SANTA BARBARA MONTECITO PLANNING COMMISSION
Staff Report for the Bagdasarian-Karman Appeal of
the P&D Director's Denial of 09LUP-00000-00256

Hearing Date: October 27, 2010
Staff Report Date: October 8, 2010
Case No.: 10APL-00000-00016

1.0 REQUEST

Exhibit 1

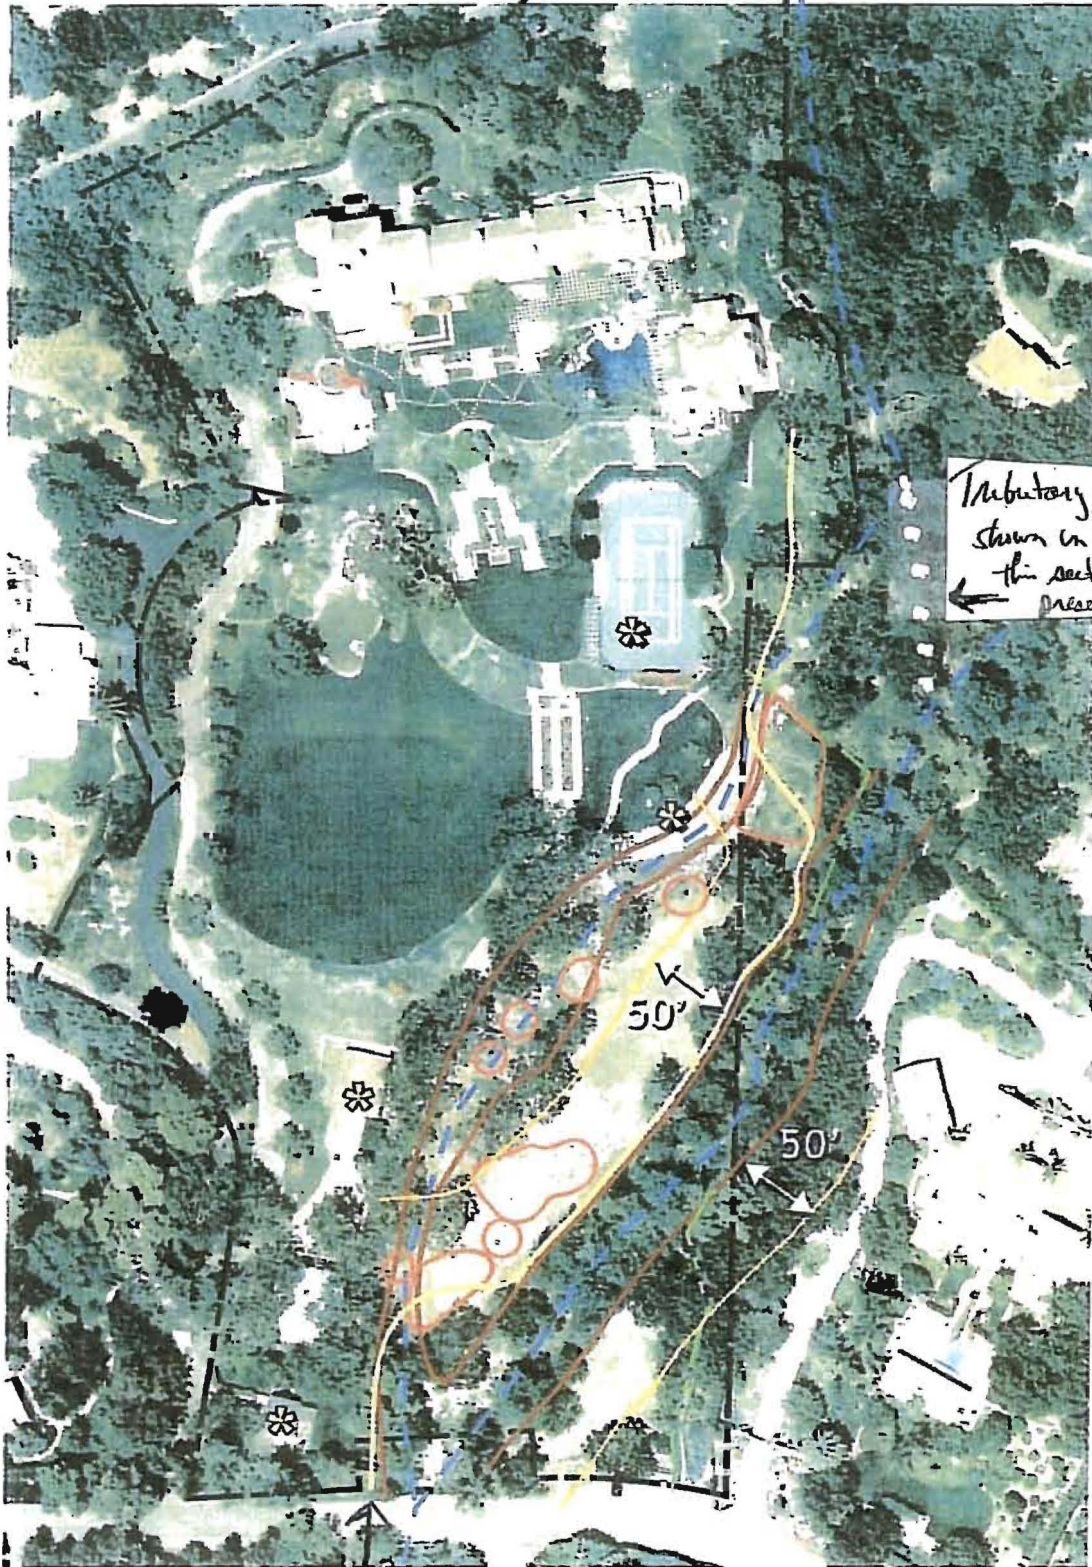
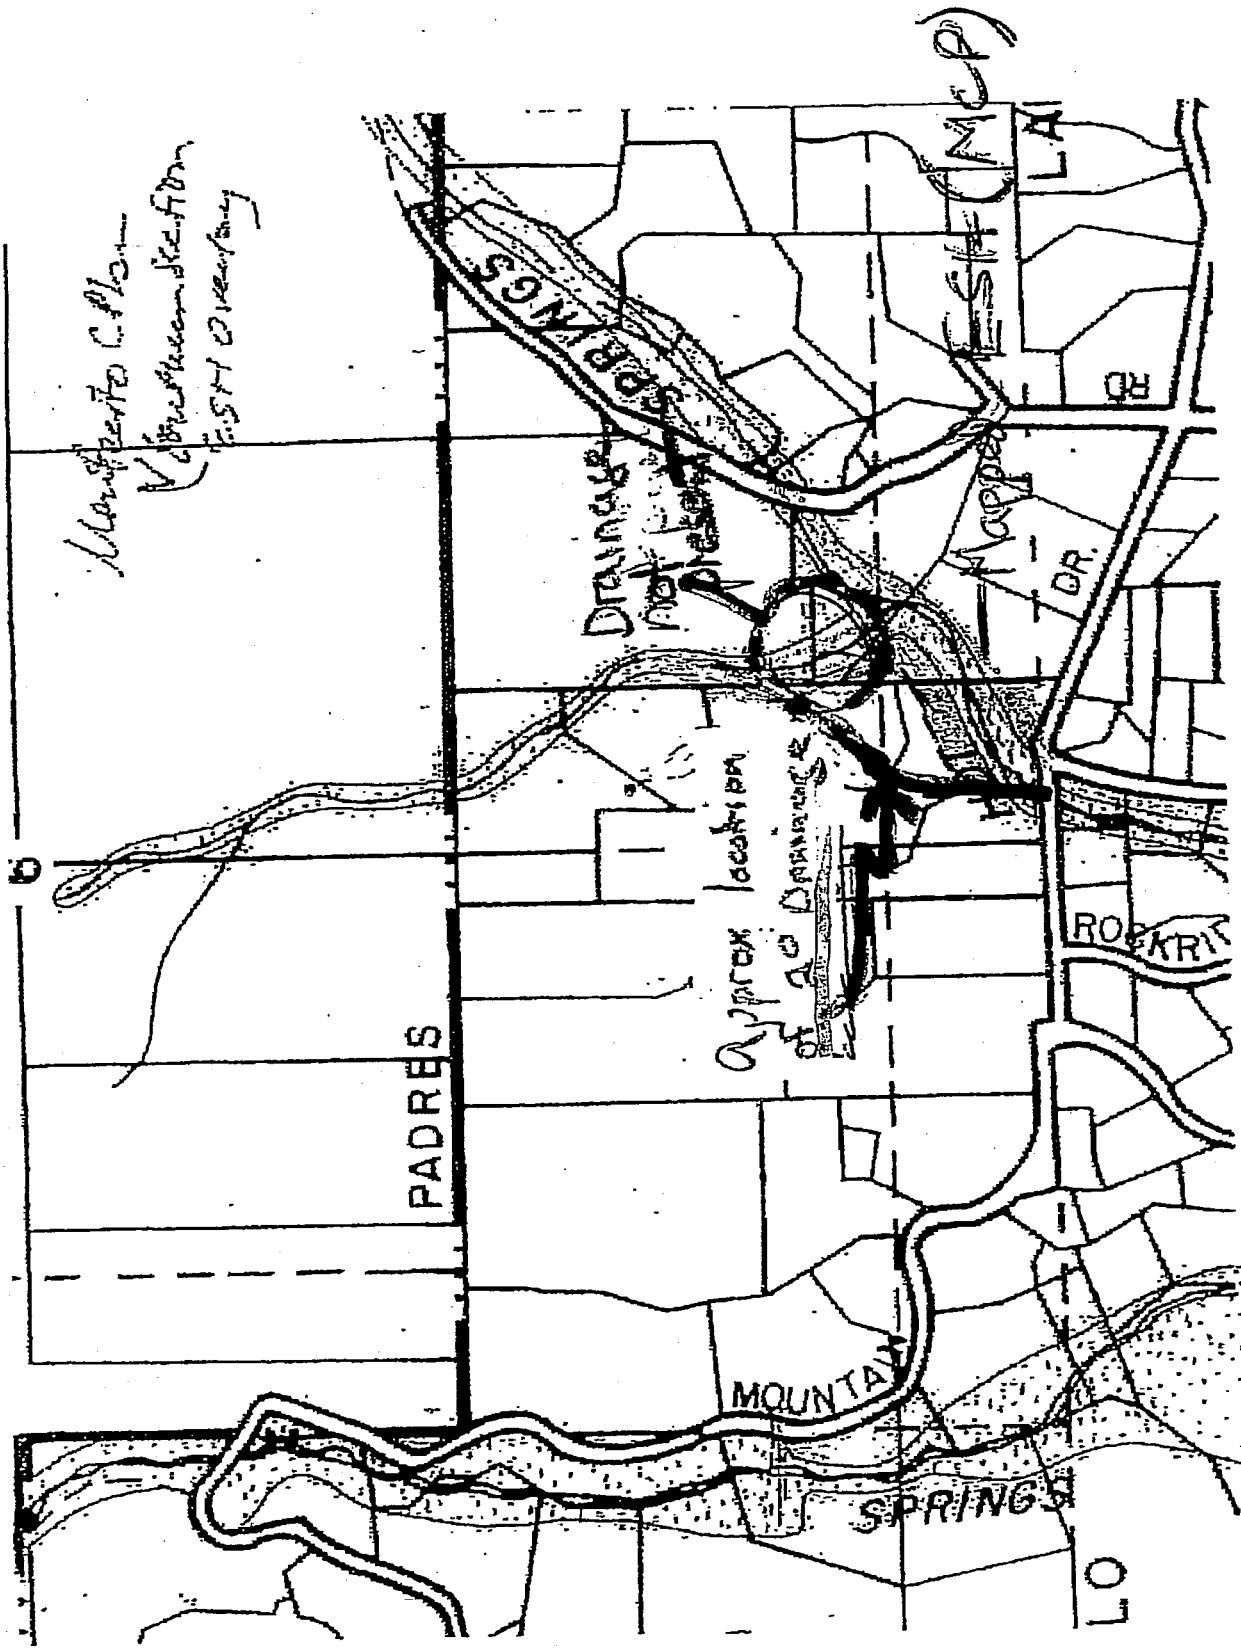
Inhibitory connection shown in MCP - this section is not present.

→ EST mapped in Bro. Assessment. Follows EST mapped in MCP.

Figure 2: Vegetation

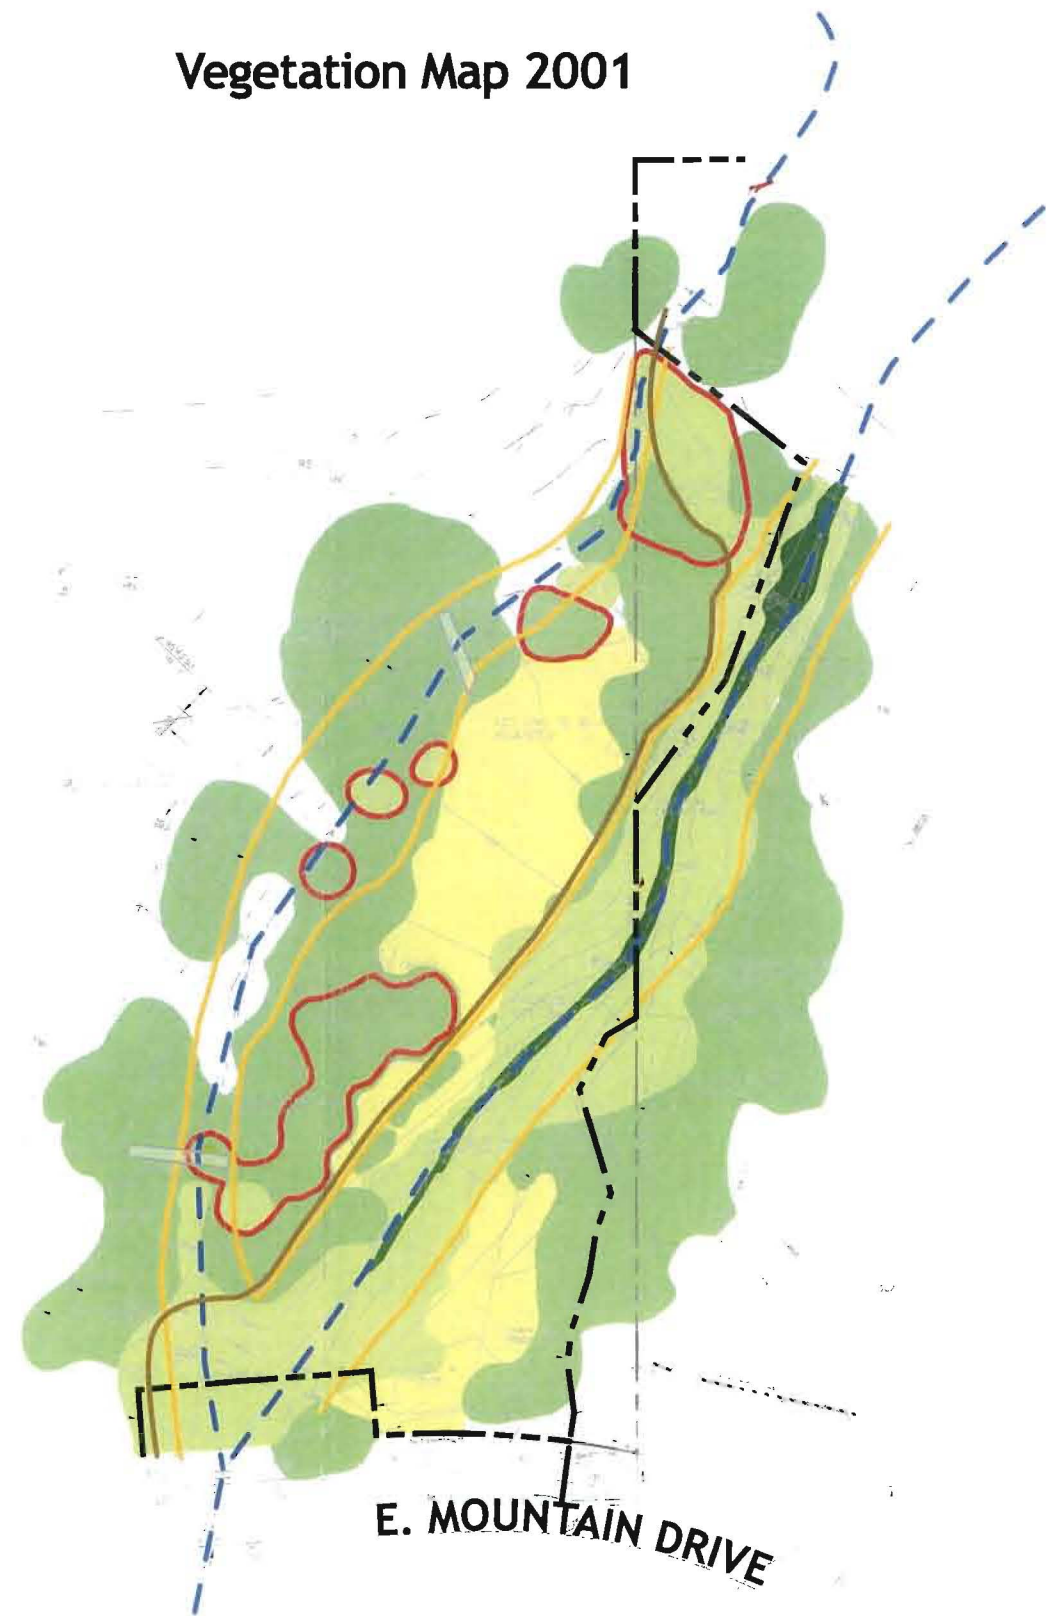
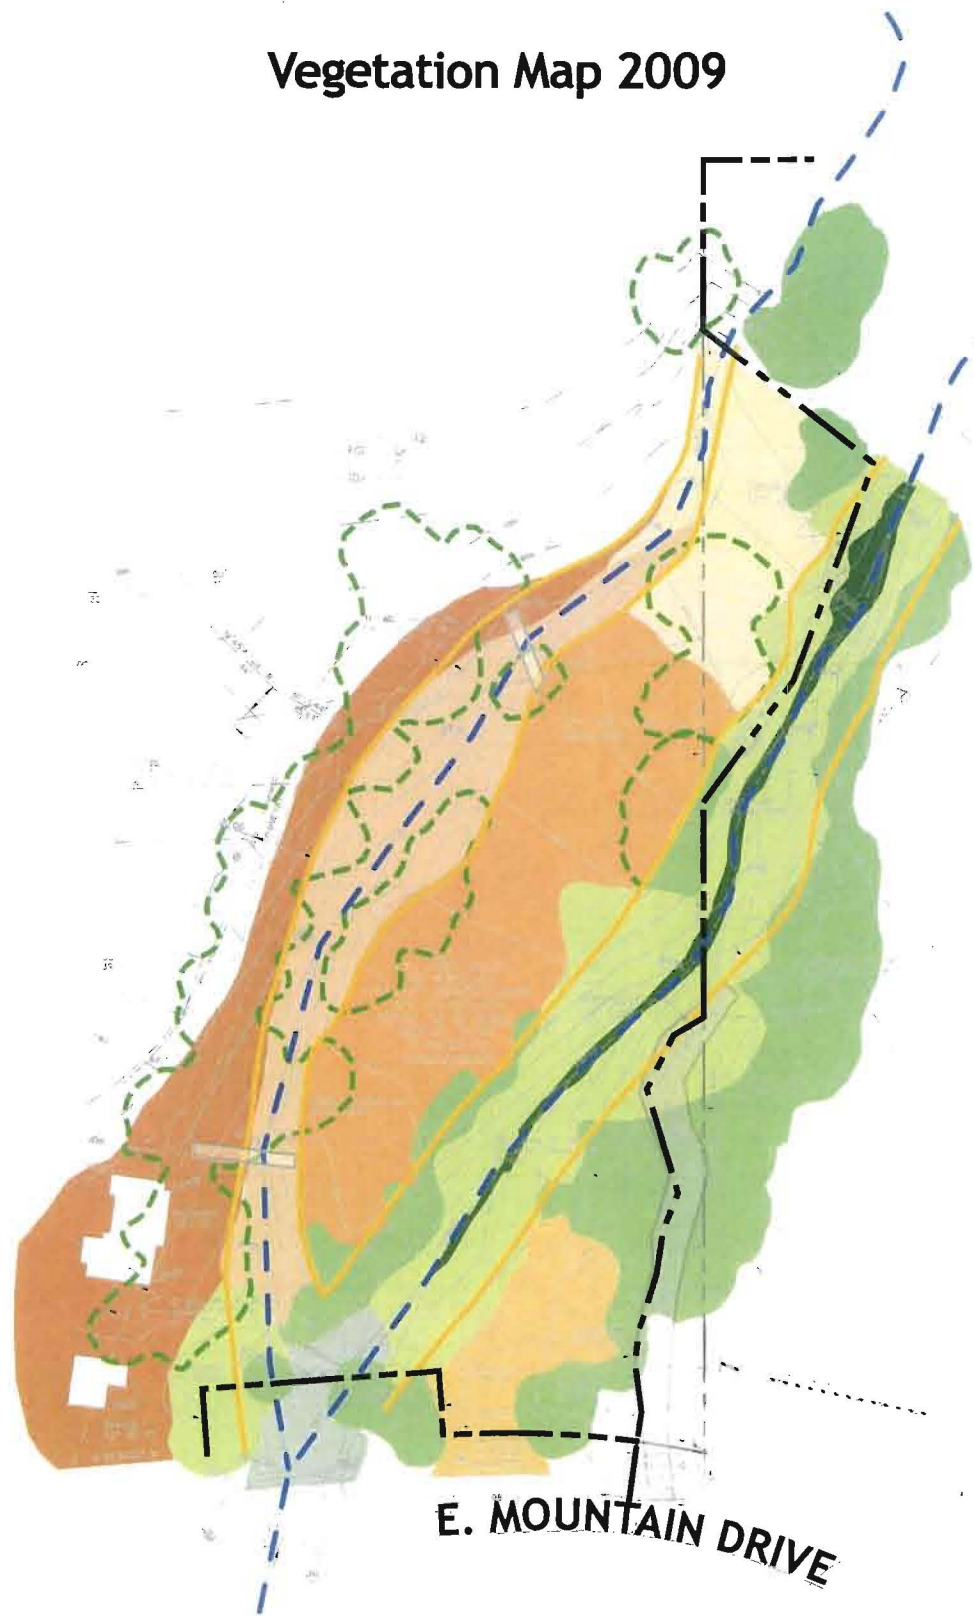
1. Page 6. Section 3.1. *Unclear and Conflicting Analysis of Pre- and Post-Disturbance Plant Communities.* In my opinion, this section does not clearly represent the pre-disturbance plant communities on site. Figure 2 compares 2001 and 2009, but the text appears to be based on the present vegetation. Table 1 compares two classification systems, not pre- and post-disturbance. It is not clear what the timeframe is. A more accurate picture would result from listing the communities present in both the secondary drainage and the Main Branch of Hot Springs Creek in both 2001 and 2009. Perhaps I'm misinterpreting something, but I don't understand how the same plant communities can be present "in 2001 and currently," when Figure 2 shows two completely different vegetation maps. Again, I'm of the opinion that the secondary drainage (the tributary) contained sycamore- coast live oak riparian prior to the as-built work, not "no corresponding natural plant community." This conclusion is based on the presence of these trees in aerial photographs prior to the disturbance (see Exhibit 7), and the MCP community plan mapping as riparian (see Exhibit 1). Perhaps the secondary drainage could be considered "no corresponding natural plant community" in 2009, but that is not what the text indicates. Finally, it is not clear why the year 2001 was selected as the end point for aerial photo review. Presumably, it is because this date most accurately reflects the pre-disturbance conditions. However, the year 2004 could just as easily have been used, as it appears, based on my review of aerials, that most of the tree removal occurred after 2004. Based on the 2008 aerial showing rock piles in the area where there is now a lawn, it is fairly clear that some work was being conducted in 2008, and that the lawn was created after 2008. *Recommendation: Clarify tables, text, and figures and indicate the rationale for using 2001.*

3. *Unclear and Conflicting Graphics for Pre- and Post-Disturbance Analysis.* Figure 2 contains errors and does not clearly label Environmentally Sensitive Habitat pre- and post-disturbance, as the report is intended to do. The Legend appears to apply to both maps, but clearly some categories apply to 2009, and some apply to 2001. "Trees removed since 2009" should be "...since 2001." "Vegetation Map 2001" appears to show mapped ESH, but it is not clear why the secondary drainage is not included, when it clearly included sycamores in 2001. "Location of ESH" could be more thoroughly explained – I assume it means pre-disturbance as determined by the biologist, but this should be clarified and made explicit. I would add SB County mapped ESH either on this figure, or as a separate figure in the report. Again, looking at the 2001 figure, it is evident that both sycamores and coast live oaks were present in the Secondary drainage. I believe extending the study area (and the map) further upstream and downstream would provide a more landscape level view of the area, and would result in the conclusion that the secondary drainage should be considered ESH prior to the as-built work. *Recommendation: Separate Figure 2 into two figures, each with its own legend. Clarify and/or explain what "location of ESH" means in the legend. Fix dates. Add mapped ESH and show what ESH might have been in 2001, pre-disturbance.*

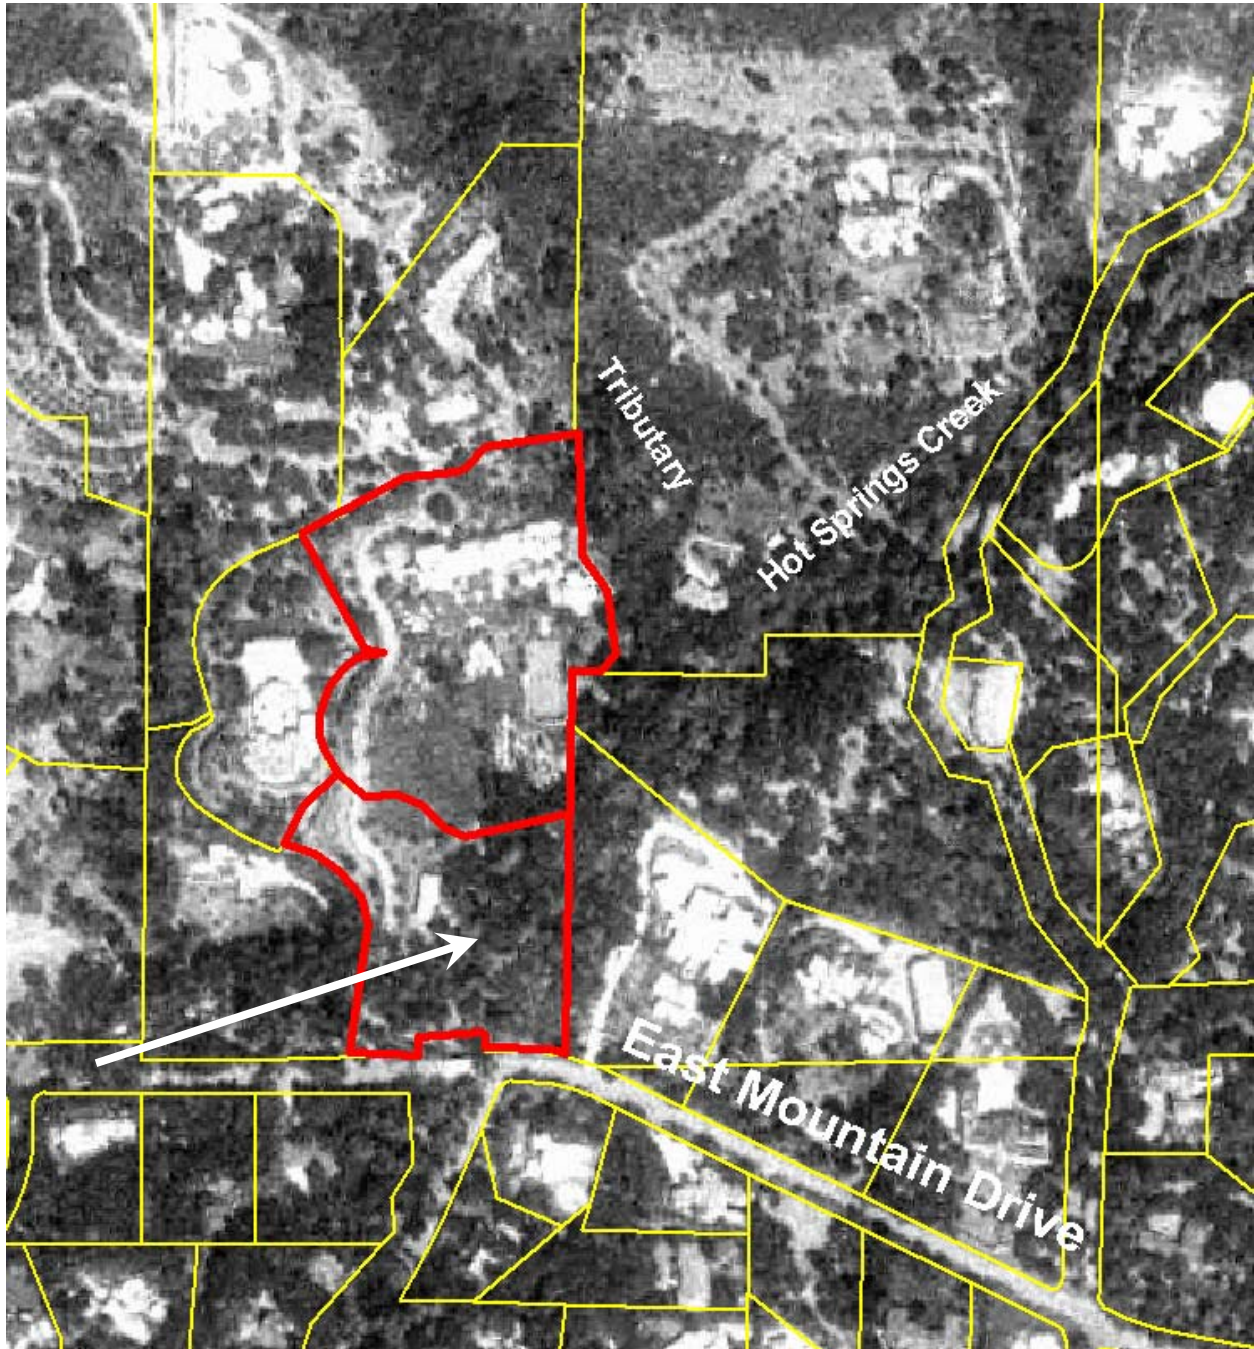
2008 Aerial Photo of Bagdasarian Property and Creek System Overview – The source for the blue line representing Hot Springs Creek and its tributary is the USGS 7.5 minute quadrangle topographic maps. The green shading represents the County's mapped ESH. The site is outlined in red. Note that the tributary in question is a significant tributary to Hot Springs Creek and that ESH mapping in 1992 encompassed the entire tributary.
